## Parks, Reserves and Foreshores Referral Response

<b>Application Number:</b>	DA2019/1190
<b>Date:</b>	01/06/2020
<b>To:</b>	Daniel Milliken
<b>Land to be developed (Address):</b>	Lot 1 DP 651395 , 9999 Pittwater Road BROOKVALE NSW 2100 Lot 1 DP 784268 , 9999 Pittwater Road BROOKVALE NSW 2100 Lot B DP 966128 , 9999 Pittwater Road BROOKVALE NSW 2100 Lot 6 DP 785409 , 9999 Pittwater Road BROOKVALE NSW 2100

Figure 1 Existing Shadows from trees throughout day at mid-winter

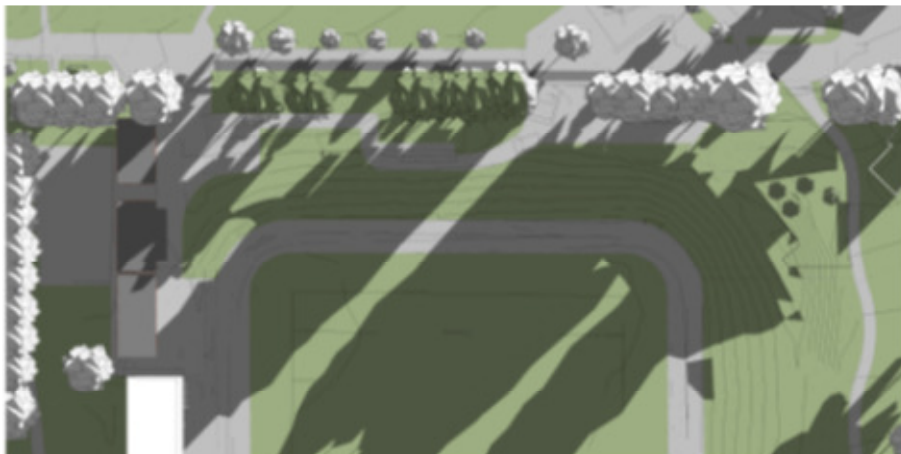
The current impact shown in Figure 1 with shadows from the existing trees fails to acknowledge that there is lateral movement of the shadows across the playing surface during the day and that the shadow through tree canopy is not solid and therefore the playing surface receives some lateral sunlight throughout the day. Figure 2 emphasizes that the solid shadow will result in no sunlight to the playing surface at the mid-winter morning period, when dew is also present on the surface that leads to disease such as fungus impacting grass health.

The shade conditions from the solid shadow will be present from mid-May to mid-July at the very least, during training and playing days and thus a reduced playing surface quality. Thus the expectation of a suitable playing surface may only be managed through increased maintenance activity or replacement of grass and higher operational costs.

In seeking out expert opinion, Council's Parks section have liaised with SportEng (Sports Field Industry) who provided a Tech Note that concluded the northern end of the playing field will be affected by shade in the mid-winter period, and that a translucent roofing has not necessarily mitigated the need for turf replacement or grow lights.

Concern is raised that the quality of the playing surface will be impacted requiring additional maintenance, repairs or replacement of the playing surface. Providing a continuous high quality playing surface will be difficult unless significant resources are provided to manage the impact.
